DUKE ENERGY

GAS DEPARTMENT
 DUKE ENERGY
 ERLANGER DISTRICT N.T.S.

AUTHORIZED
 SEP 25, 2017
 CONSTRUCTION
 DRAWINGS

PROJECT ACTIVITY		BIG BONE		DRAWN	ENE	09-25-17
INSTALLATION	R2190	I		CHECKED	DK/EK	09-25-17
ABANDONMENT	R2190	X		APPROVED	JP	
RENEW SERVICE M-C	MCNEWPI0	I		CLOSED BY		
RENEW SERVICE C-M	CMNEWPI0	I		EST. FOOTAGE	50749'	
RELOCATE METER	GMSMOVE	X				
MAP NO. S 0 5 W 0 2 - 4 7		DRAWING NO. 8 2 0 5 8 0 4

21
54

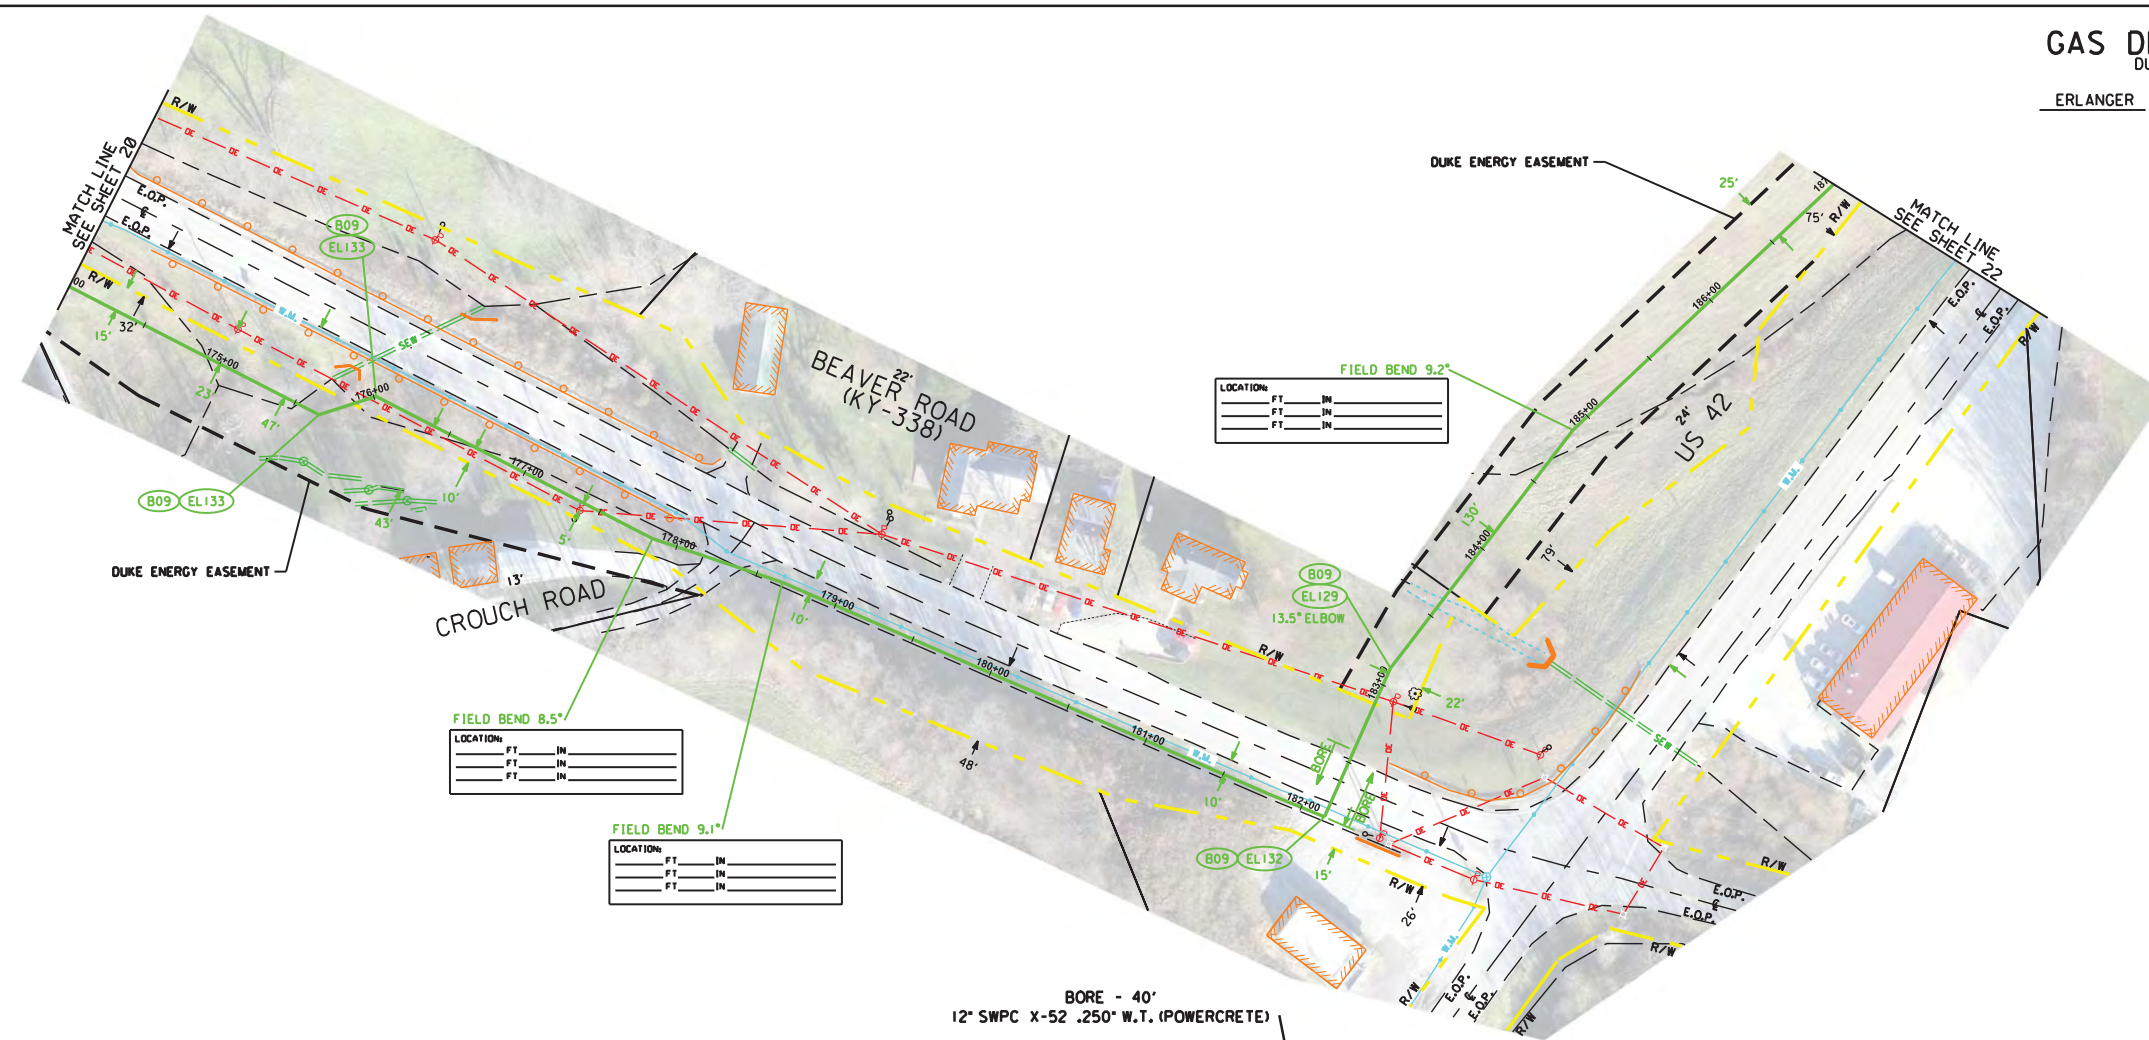
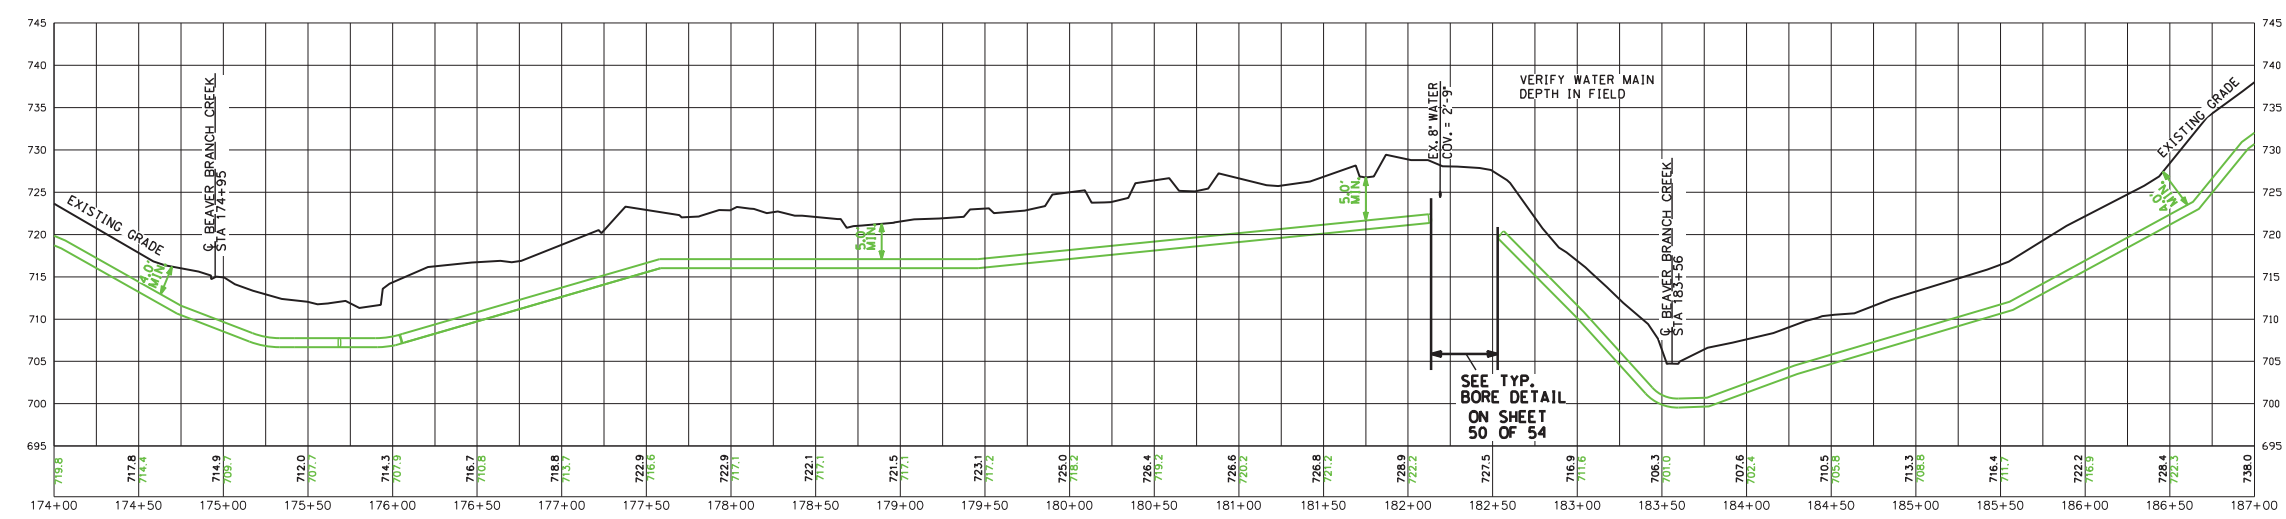
REVISION 1: VALVE RELOCATION FROM SHT 21 TO SHT 20.

23
54

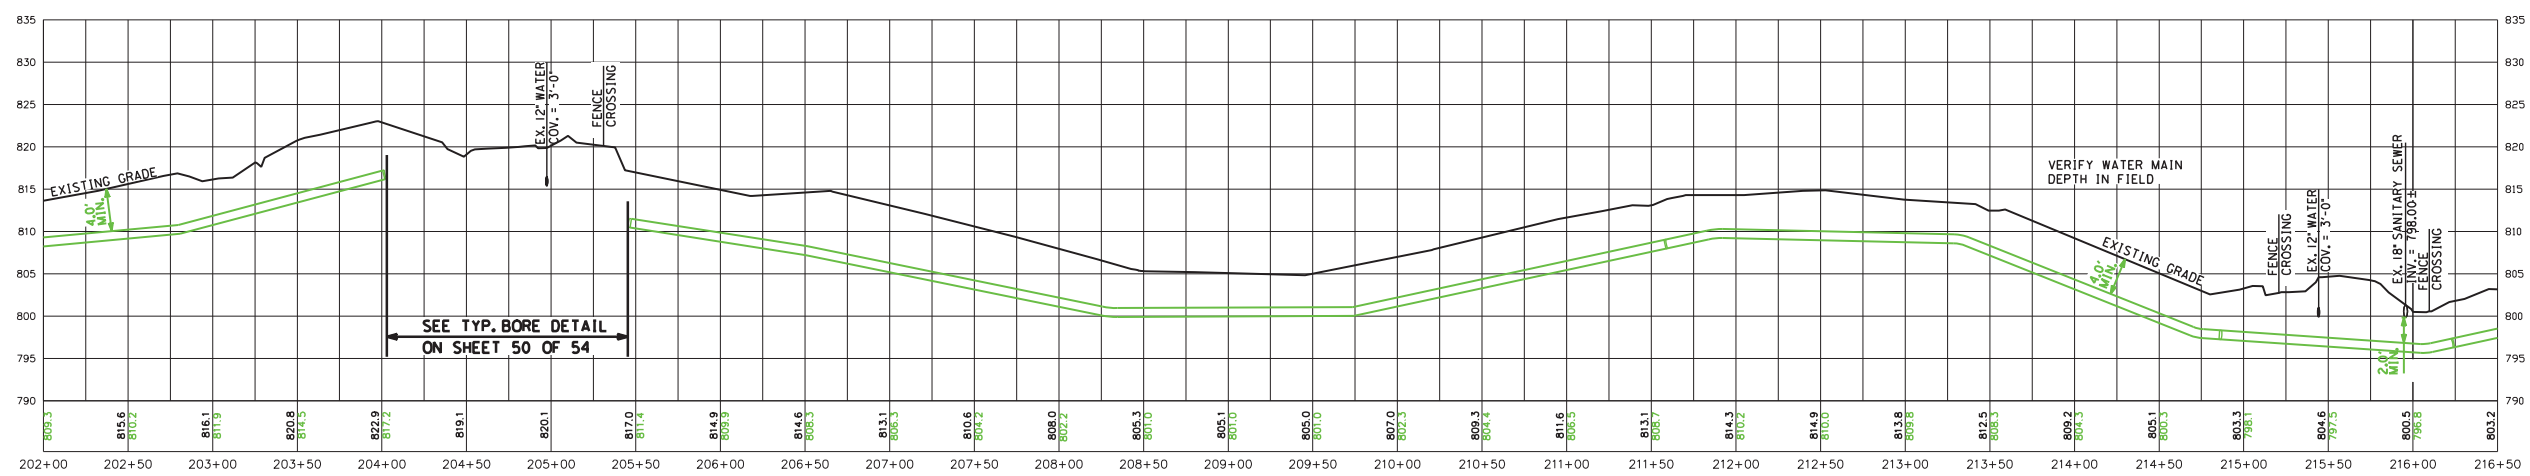
REVISION 1: CHANGED CROSSING AT STA 215+68 FROM BORE TO OPEN CUT.

38
54

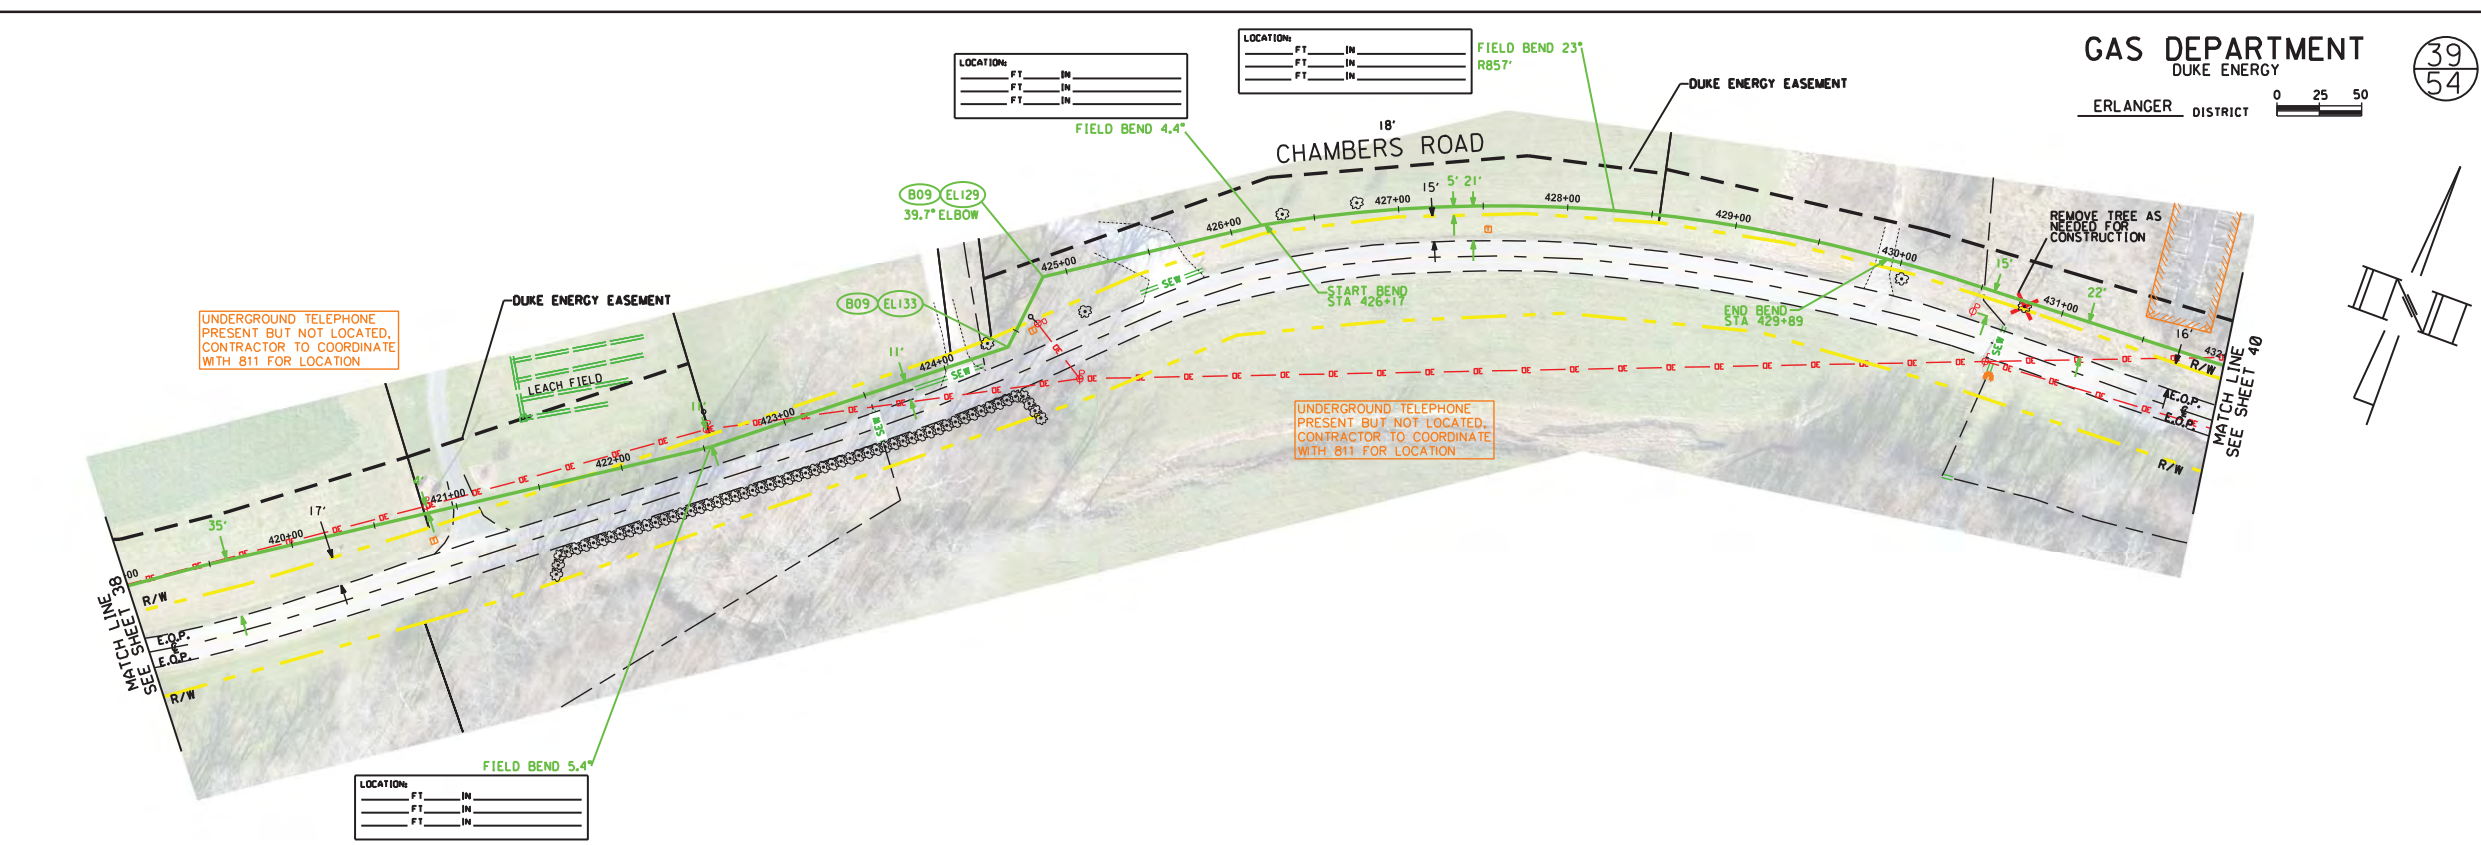
REVISION 2: UPDATED FIELD BENDS TO FITTINGS AT STA 417+50, 418+50 & 419+00.

41
54

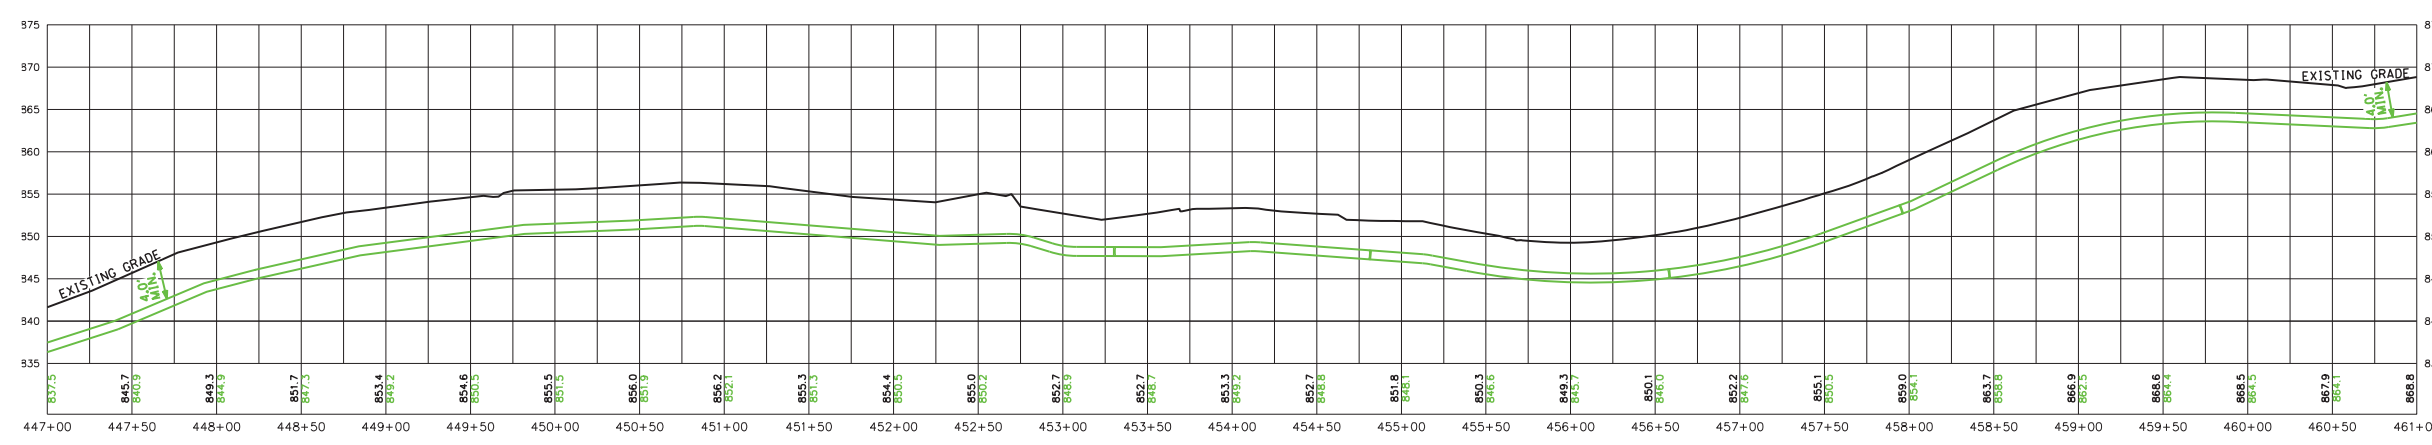
REVISION 2: UPDATED TO REPLACE FIELD BENDS WITH FITTINGS AROUND CURVE.

42
54

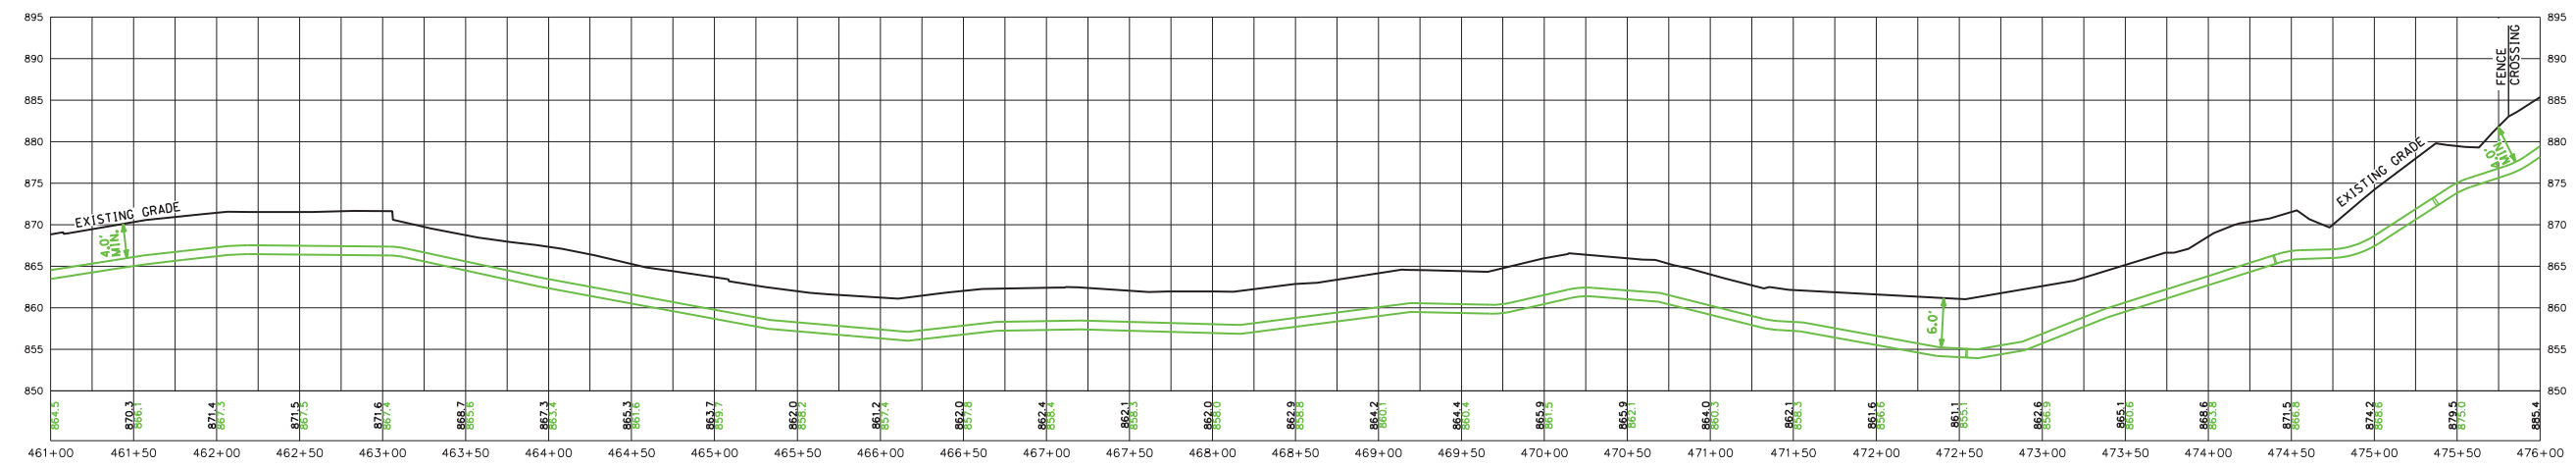
REVISION 1: ADDED 6' COVER NOTE ON PLAN VIEW.

43
54

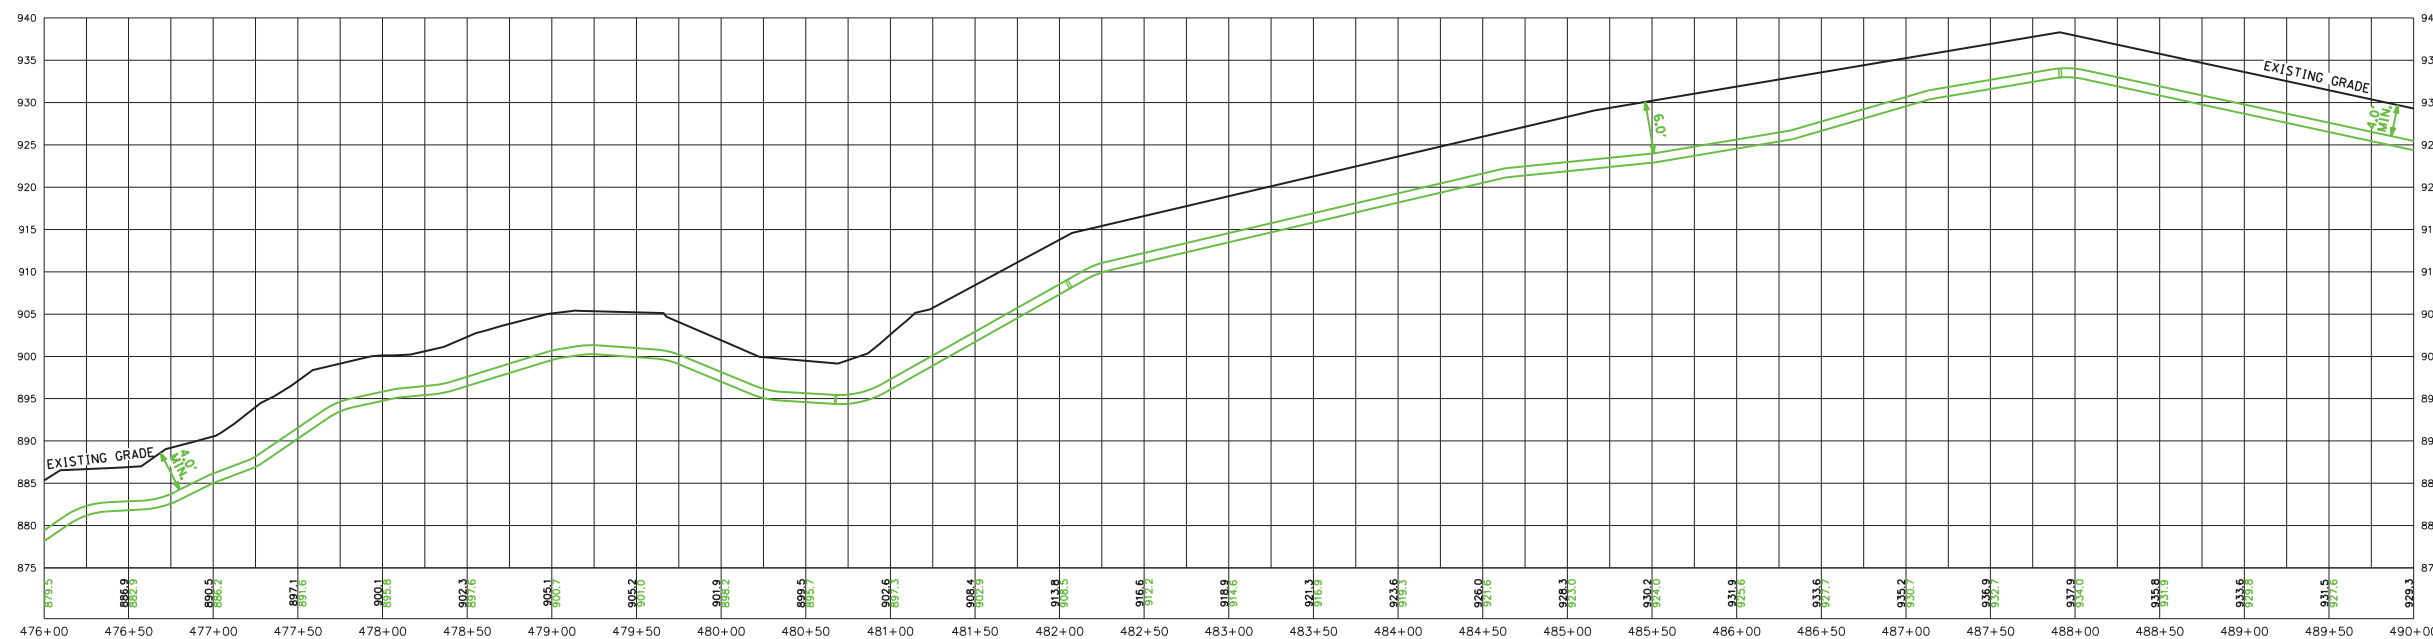
REVISION 1: ADDED 6' COVER NOTE ON PLAN VIEW.
